Access Audit

The Redeemer Church of England Primary School

**Jack Walker Way
Fernhurst Farm,
Blackburn
BB4 4JJ**

21st January 2022

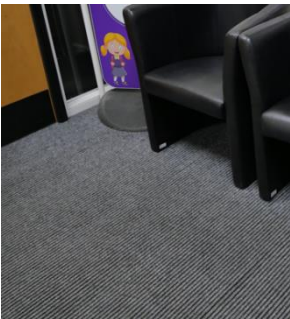
Provision	Photos/Evidence	On site assessment	Recommendations	Priority
5. External access routes to the building				
5.1. Public footway approaches to the school		The public footways approaching the school from both North and South are reasonably level, well lit, wide tarmac surfaces in good order, with cycle paths marked.	None	N/A
5.2. Highway crossings		There are 2 zebra crossings located to the North and South of the school frontage, which are raised to footpath level. The alternate black and white ground markings are extremely worn and require remarking which is the responsibility of the Highway Authority.	Report the worn zebra crossing marking to Blackburn with Darwen Borough Council - https://www.blackburn.gov.uk/roads-and-highways/roads-report-problems	High
